**RISK MANAGEMENT PLAN
DUTCH BOY SITE**

**NL Industries, Inc.
Chicago, Illinois**

The U.S. Environmental Protection Agency (EPA), the City of Chicago, and Technical Outreach Services for Communities (TOSC) have reviewed the July 1998 "Risk Management Plan- Dutch Boy Site". The EPA hereby approves the document with the following modifications, which are listed in Section A below:

RE: City of Chicago's comments -- NL Industries, Inc.'s *Risk Management Plan - Dutch Boy Site*, USEPA Unilateral Administrative Order V-W-96-C-347

Figure
3

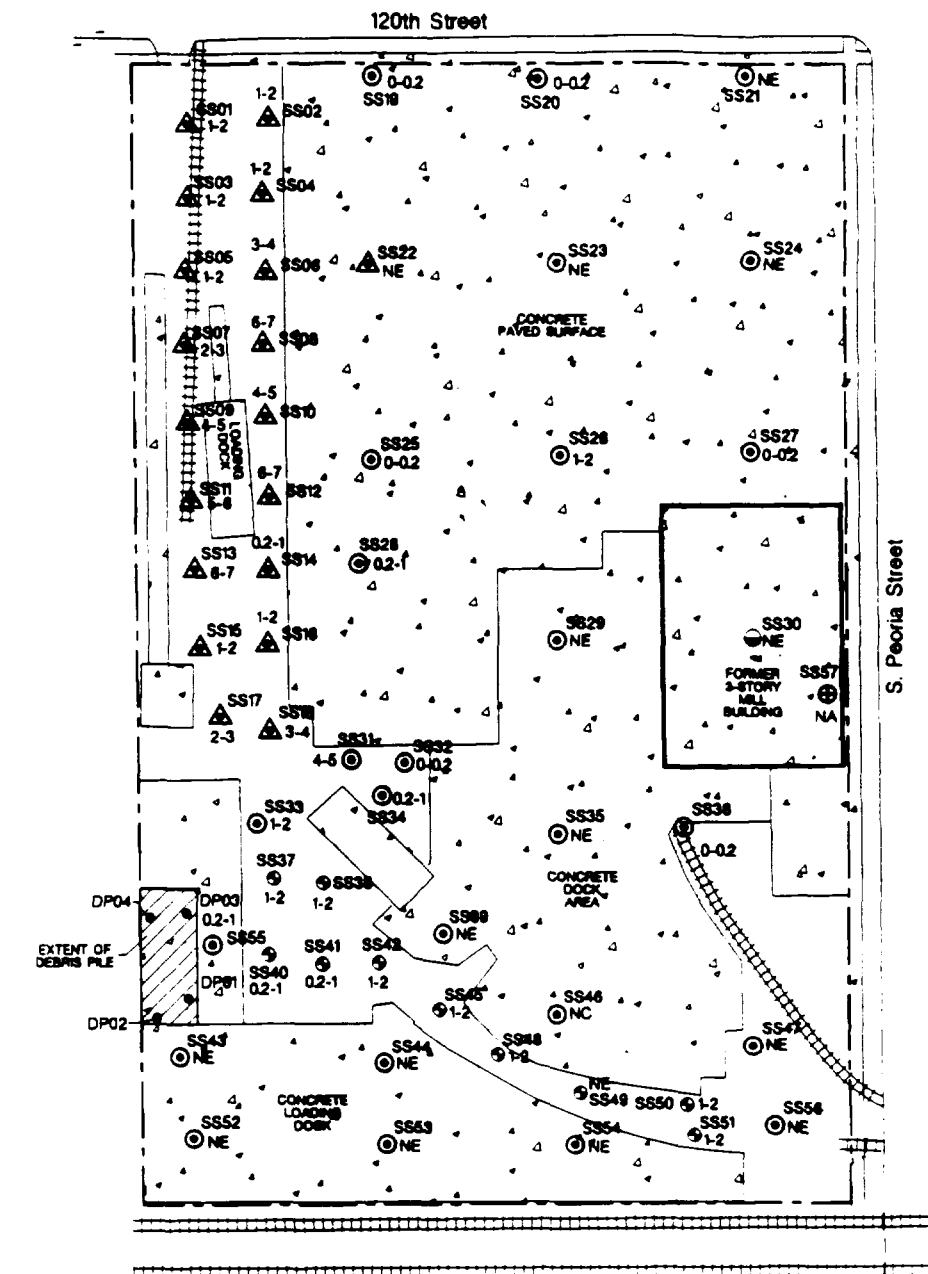
3. Page 5, Section III, paragraph 2, lines 4-5 reads: "The areas most effected (*sic*) are the former rail spurs leading to the loading dock in the northwestern portion of the Site. Figure 3 shows the extent of contamination exceeding the cleanup goal."

It would be more accurate to say that the most affected areas are the unpaved portions in the western region of the site and the paved areas under and adjacent to the former mill building. Additionally, Figure 3 is not sufficiently illustrative of the extent of contamination. We have scanned and modified Figure 4 to create three figures that better depict the extent of vertical and horizontal contamination (see attached).

Table 2 (revised by TOSC)
Summary of Data from Unpaved Area Boreholes
Dutch Boy Site: Chicago, Illinois

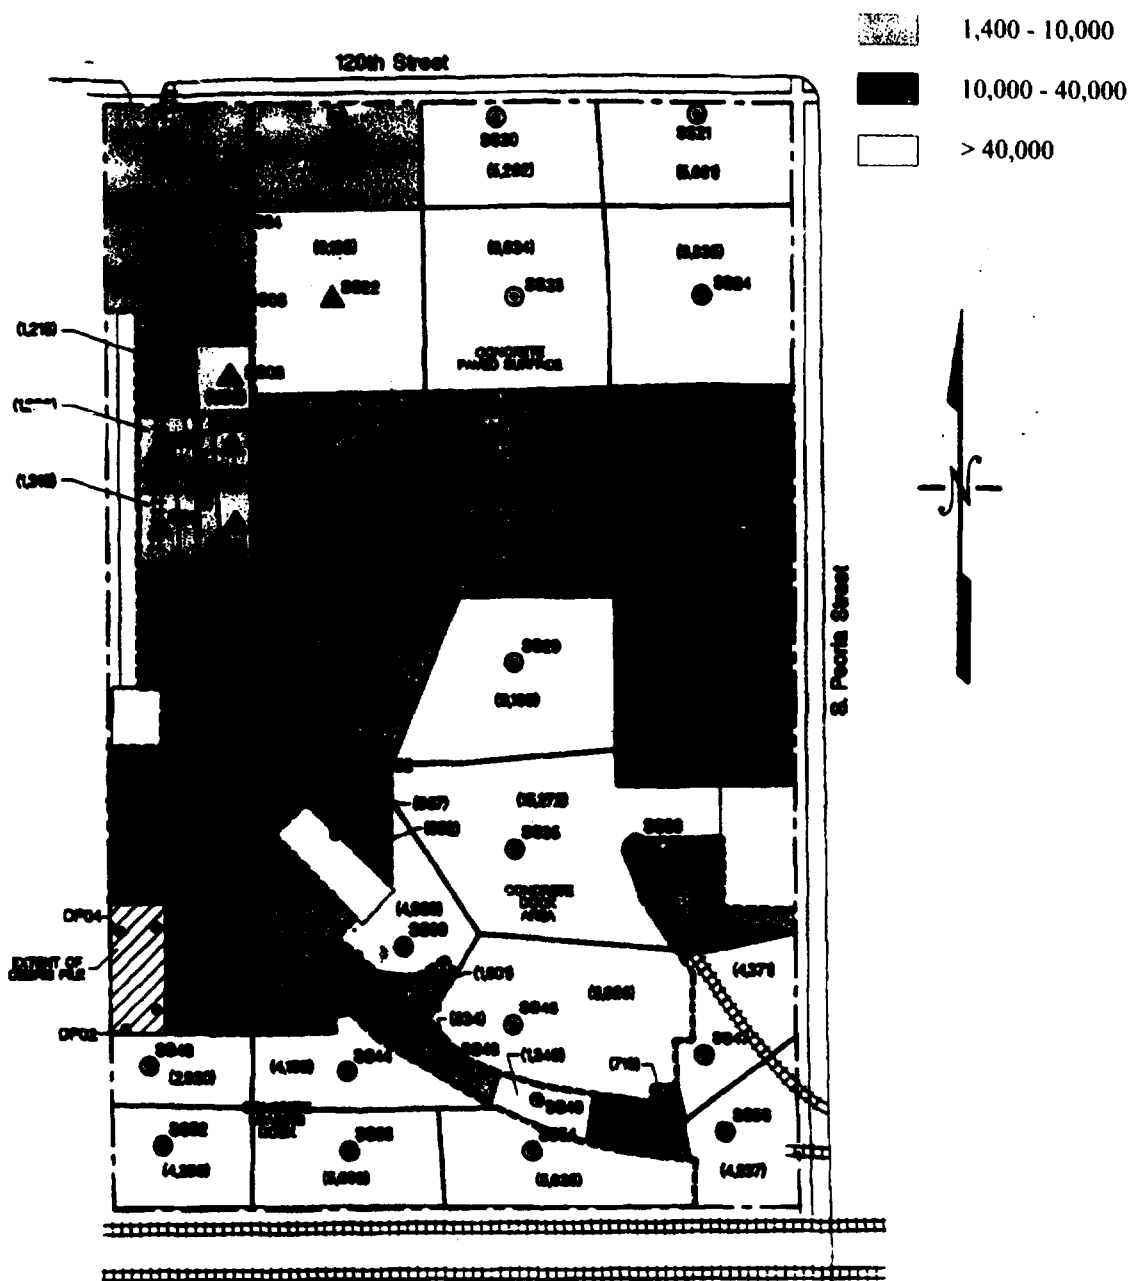
In reviewing the data in this table, three errors were found. We have attached a revised version of Table 2, correcting these errors and providing an explanation for the suggested changes (see attached revised Table 2). While the data for SS42 is inconsistent with Figure 4, the error may actually be on the figure and not in the table. Nevertheless, it was more advantageous to use this revised Table 2 to point out the problem. Although not stated on our revised table, correcting these errors slightly alters the total volume of soil to be excavated. Since these volumes should only be used in making cost estimates, not in determining the final volume of soil to be excavated (confirmation samples collected in the floors and sidewalls of the excavation site will be necessary for that), these changes are relatively inconsequential.

^a In the original ENVIRON RMP, the volume of soil greater than 2 feet was neglected.

^c The area listed in the Table 2 of the RMP conflicts with the area listed in Figure 4.
